Addendum No. 1

East Jackson Boulevard Roadway Lighting Project #SE0247
City of Jackson
101 court Street
Jackson, Missouri
Eng. File No. 23-135

**HIGHWAY LIGHTING
POLES, FOUNDATIONS
AND APPURTENANCES
FOR 45' MOUNTING HEIGHT**

901.01AJ

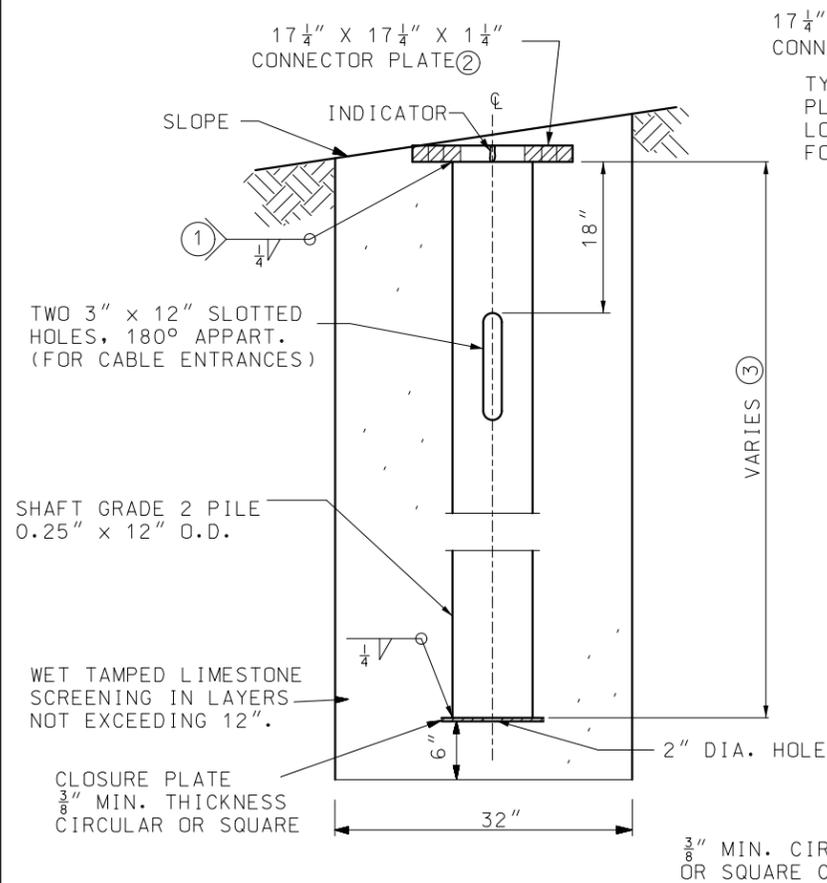
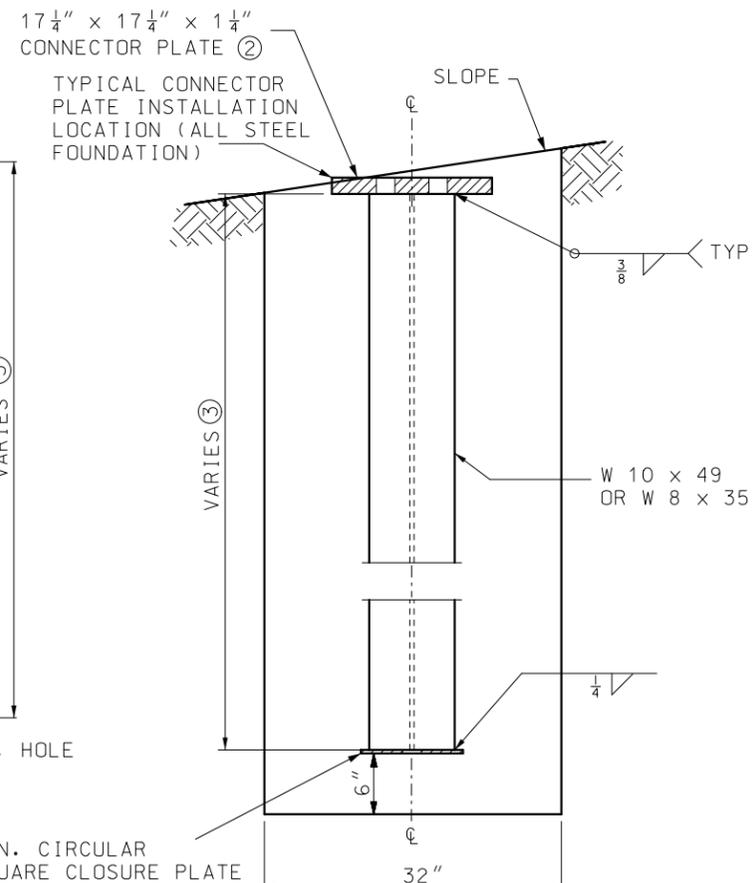
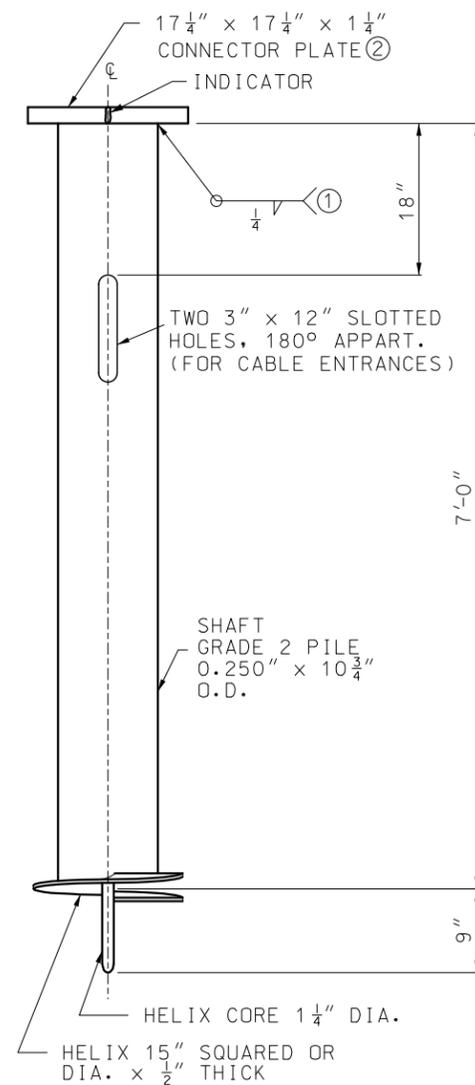
9. Bid List Item 10 (Cable-Conduit, Bored) shall include any costs related to encountering rock. No additional costs shall be paid related to encountering rock during boring.
10. Bid List Items 11 & 12: Item 11 (Pole Foundation) was revised to indicate that this covers Helix Base installation in soil with a revised quantity. Item 12 (Pole Foundation) was added to cover Steel Pile Base installation where rock is encountered. See attached MoDOT Standard Drawing 901.01AJ for Steel Pile Base installation details. See revised Bid Items List.
11. The revised Bid Items List provided under this addendum shall replace and supersede the list included in the original project manual and shall be utilized in all submitted bids.
